City of Portland, Maine - Building or Use Permit Application

Permit No: 01-039	Issue Date: APR 11 2001	CBL: 111 C003001
----------------------	----------------------------	---------------------

BUILDING PERMIT REPORT

REASON FOR PERMIT: Change of use From attic space To family room

Family Room Floor Plan Exhibit "E"
3rd flr - 100-102 Ocertfield Rd, Portland, Me

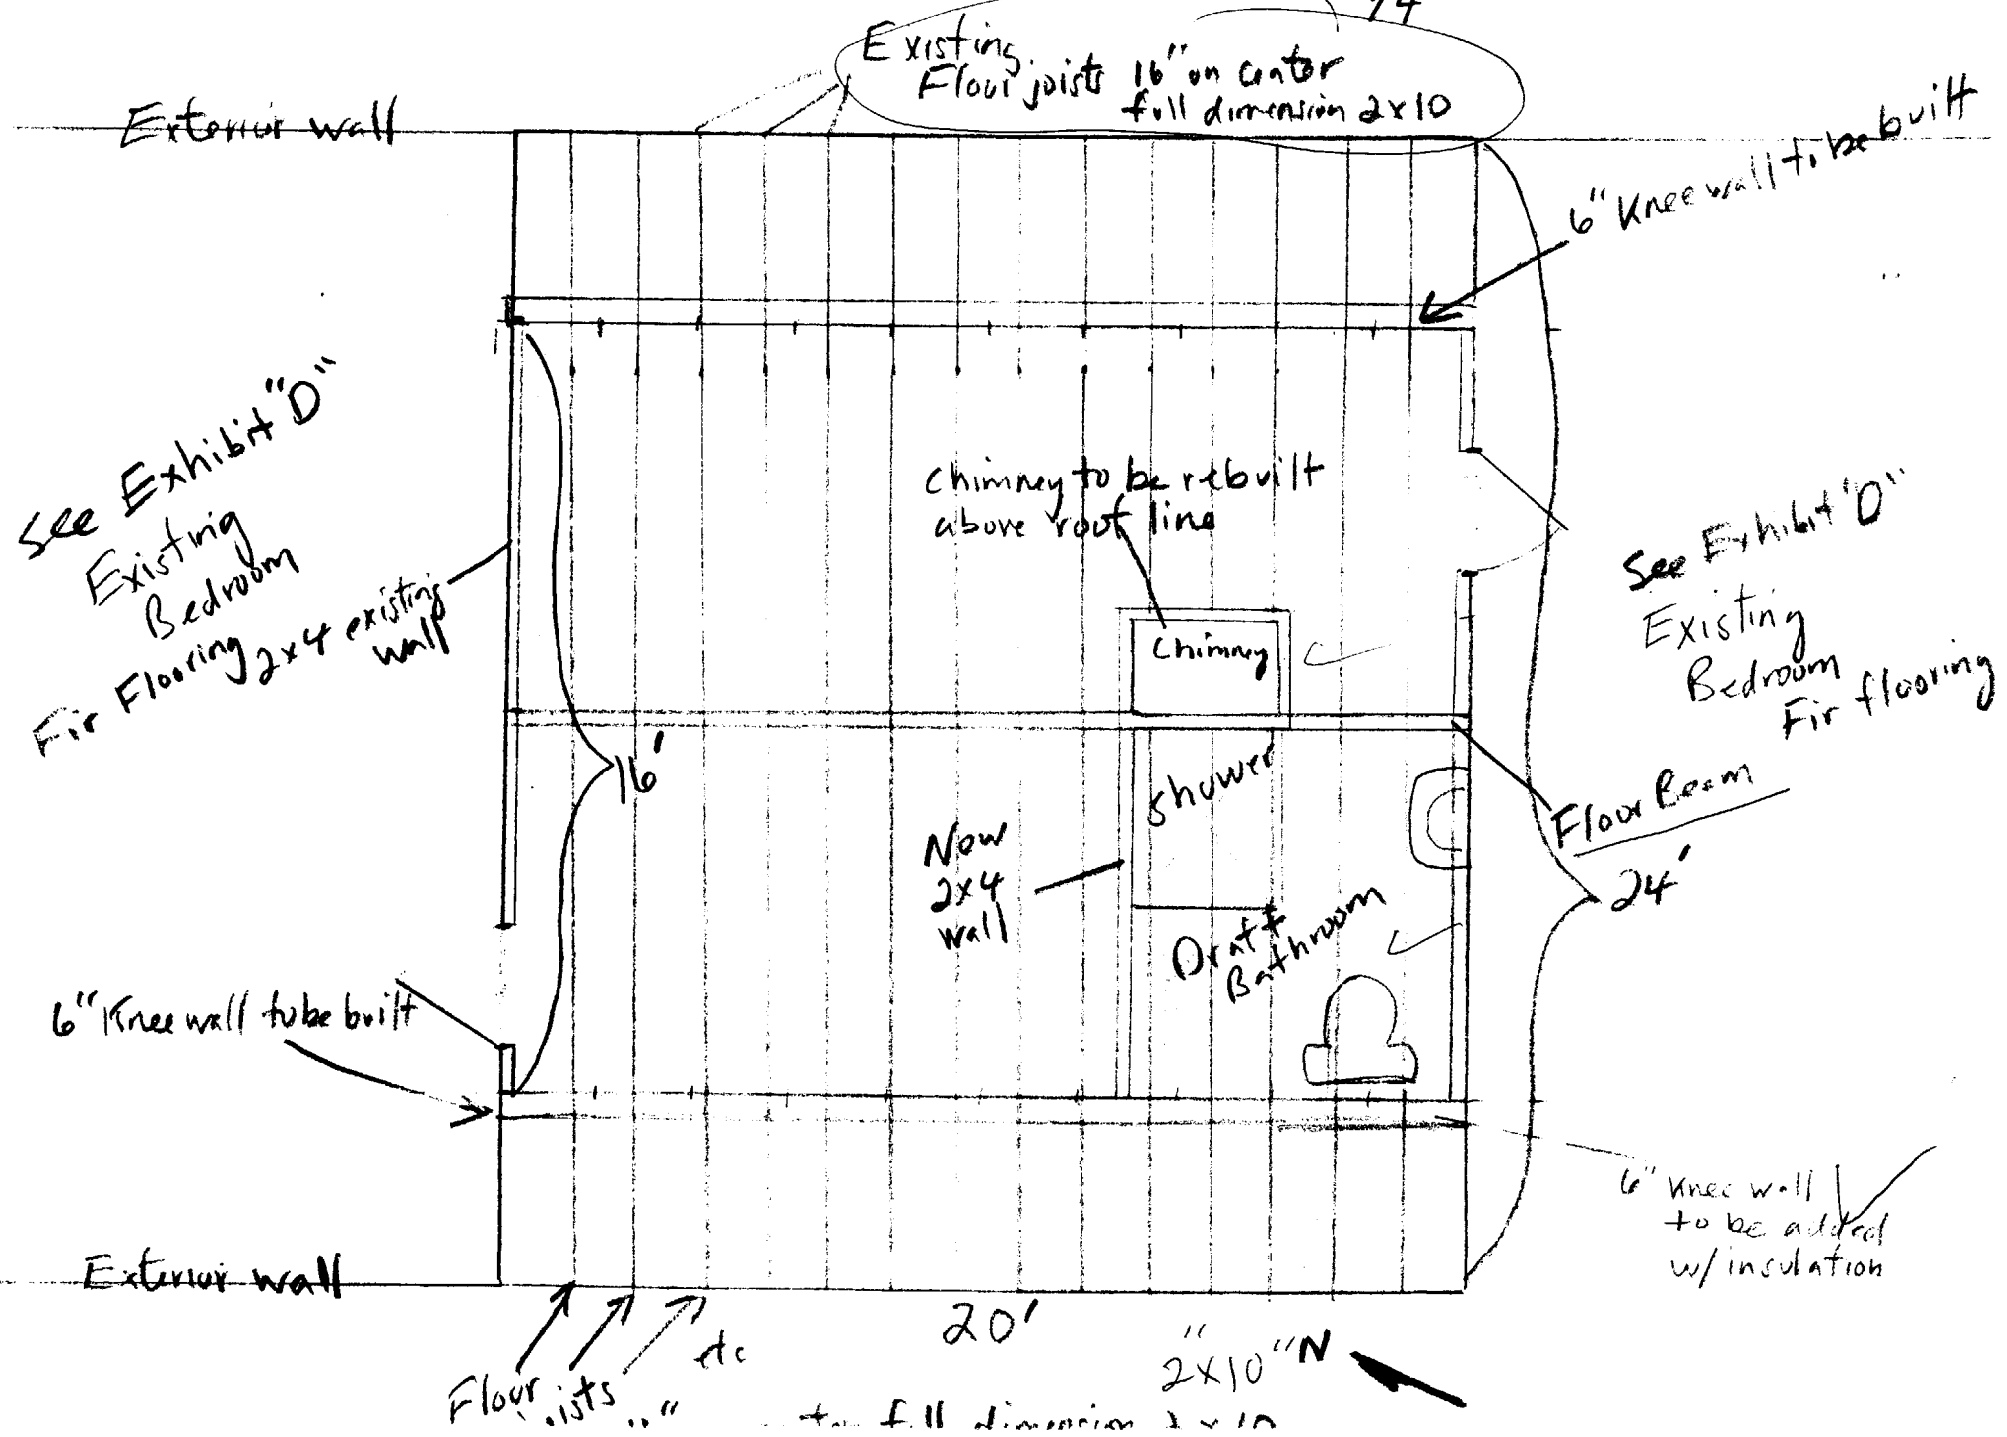
*38. *This permit is being issued with the understanding that the floor joist are 2x10 @ 16" OC. IF this is not the case you shall notify this office and submit new framing detail -*

PROPOSED KNEEWALL AND
SKYLIGHT FRAMING DIAGRAM

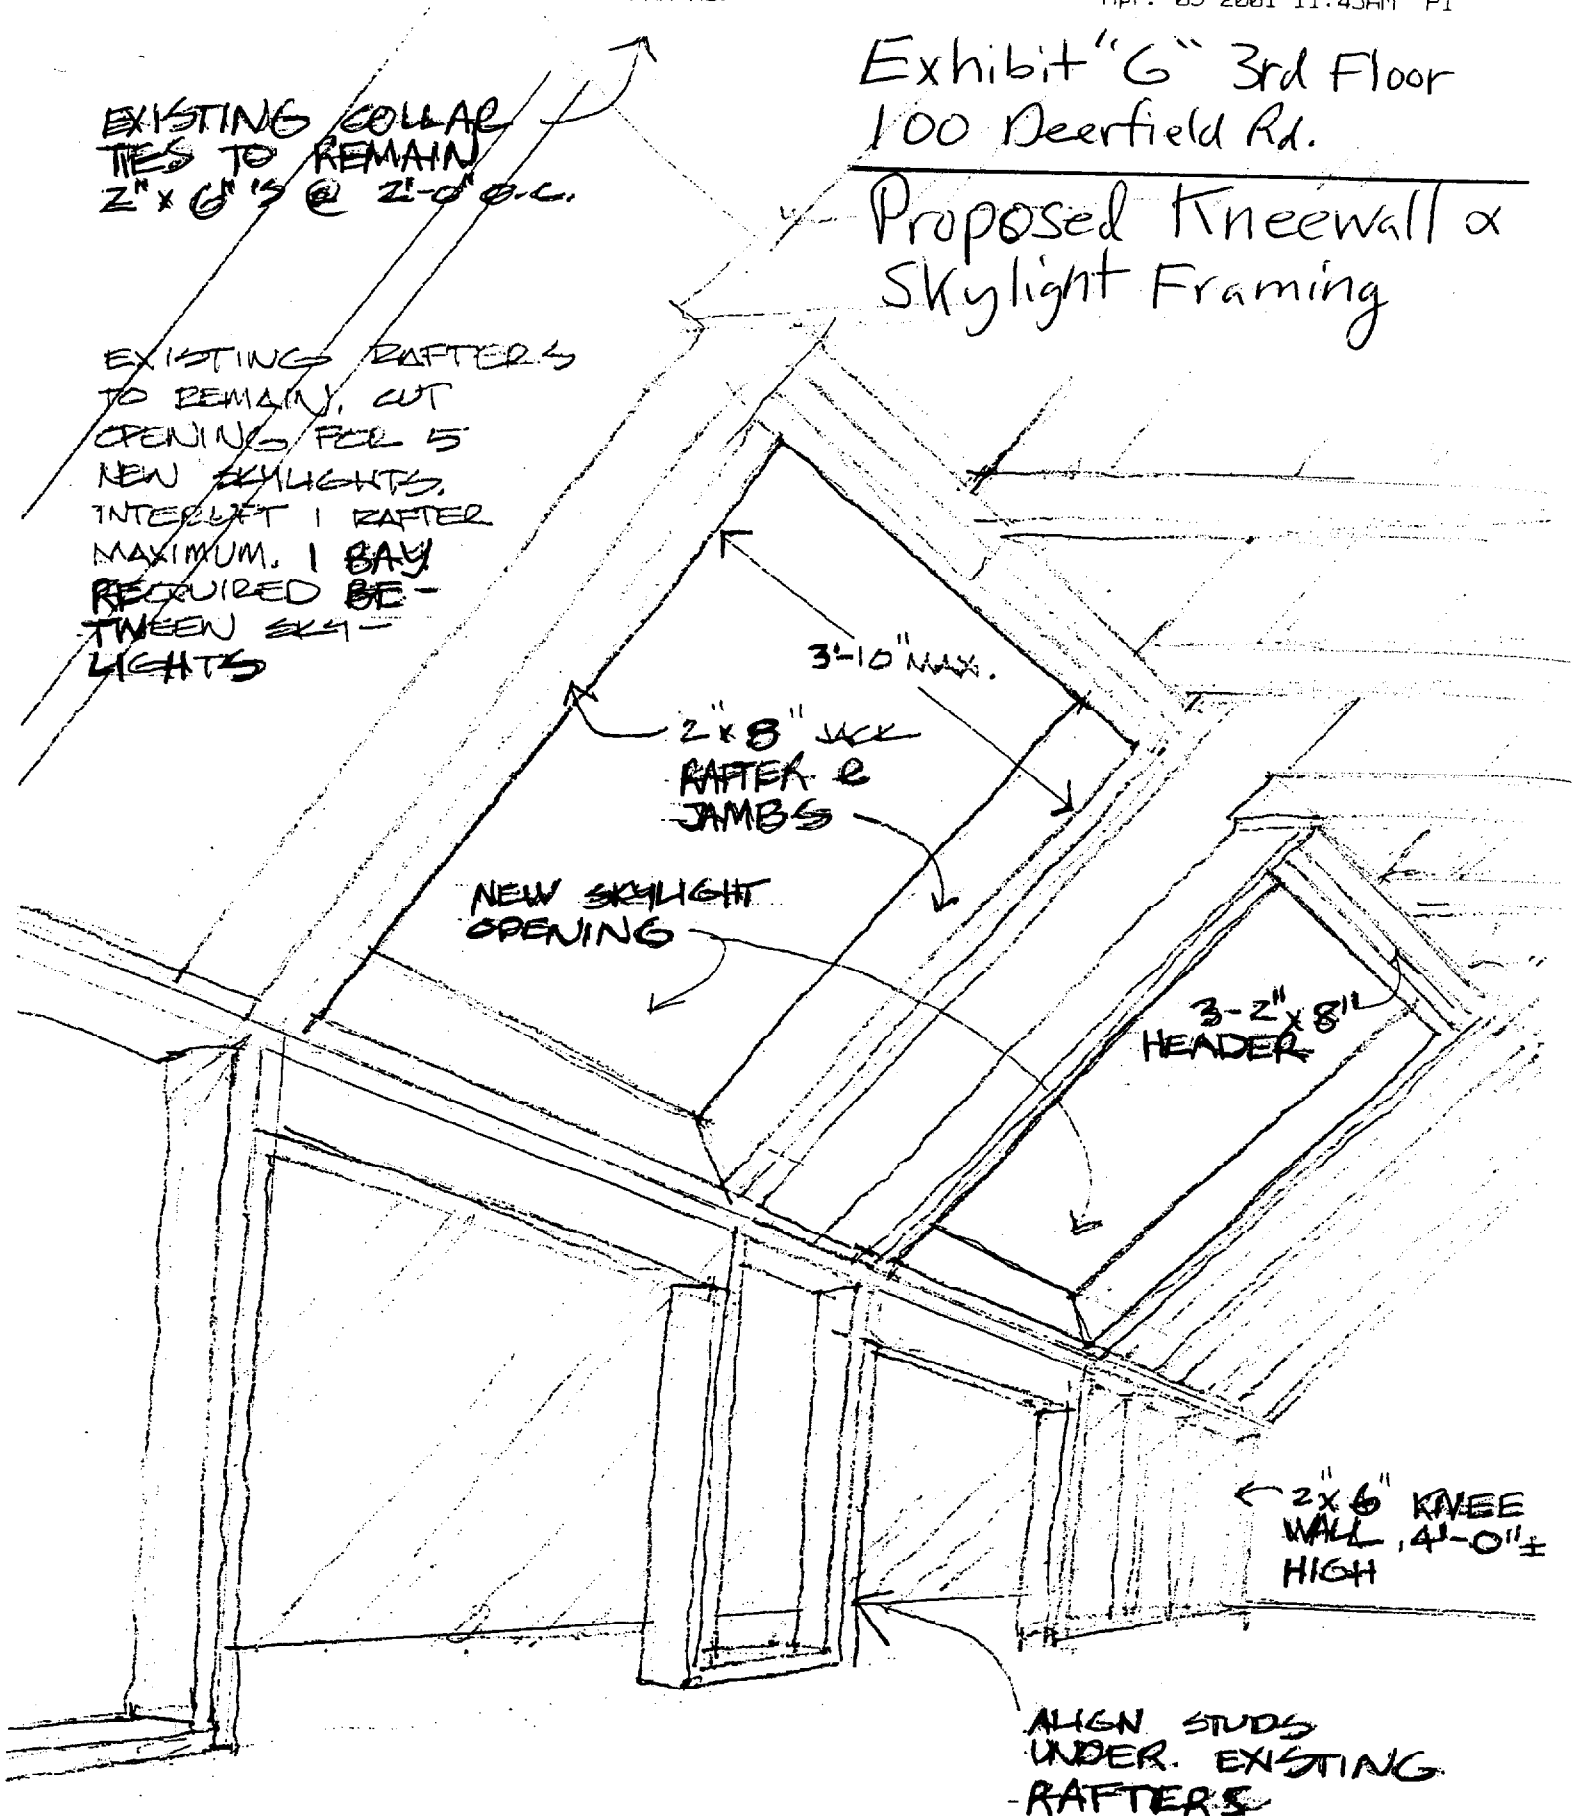
*35. Glass and glazing shall meet the requirements of Chapter 24 of the building code. (Safety Glazing Section 2406.0) *(SKYLIGHTS Sec. 2405.4)*
